Delegated Report

Householder Planning Application

Planning Application No: 20210702

Location: 25 And 26 South Hill Road Gravesend Kent DA12 1LA

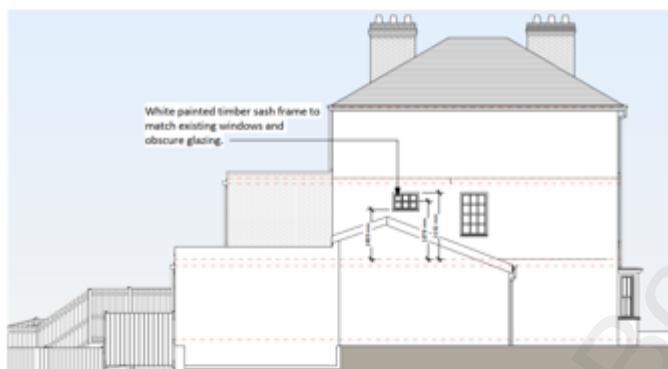
No. 25 on the right (when the properties are viewed from the rear) has a single storey rear extension (permitted under 19900248) plus a narrow conservatory and side porch (permitted under 20040863).

The proposal is to demolish the existing single storey rear extensions and the conservatory as above at the rear of the properties and erect a new part two storey, part single storey rear extension across both properties.

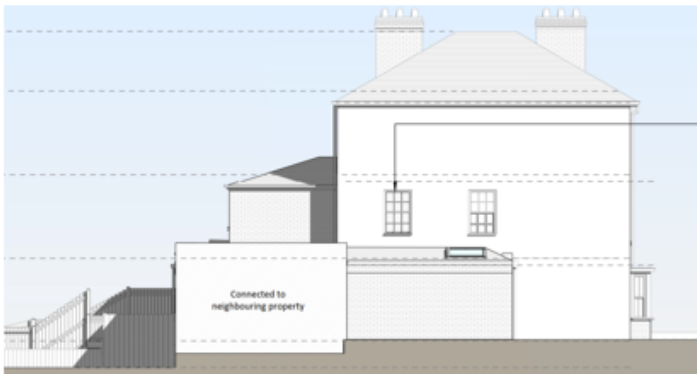
In the current proposal the extension has been revised. At ground floor the extension would still be full width (plus slight extension out to the side at no. 25) and be 5.1m in depth but at first floor level the extension would no longer be full width and would be set in from the flank elevations – 800mm in the case of no. 25 and 1m in the case of no. 26. The roof of the extension has been amended from a flat roof to a pitched roof. The height of the extension has been amended from 5.5m to 5.8m to the top of the pitched roof (4.7m to the eaves). It would have doors and glazed panels at ground floor and traditional sash windows at first floor:

The extension has been much improved in design. Due to the reduction in width at first floor level of the extension with it now being set in from both sides and the proposed pitched roof in place of a flat roof, along with a slight reduction in depth, the extension now appears as a much more subservient and sympathetic addition which would be in keeping with the scale and character of the host dwellings. The extension would allow a large part of the rear elevations of both properties to still be visible.

villas and the impact on views from just outside of the Conservation Area looking into it. With the previous application the flat roof of the extension would have been visible which would have not been acceptable due to its poor design and which would have disrupted the rhythm of the rear elevations when viewed from Parrock Road. However, now due to the reduction in size and bulk of the extension and the improved pitched roof design which would sit low down in the rear elevation, it is considered the character of the rear of this pair of villas would not be harmed nor would the views of these and the other neighbouring villas when viewed from outside the Conservation Area looking in.
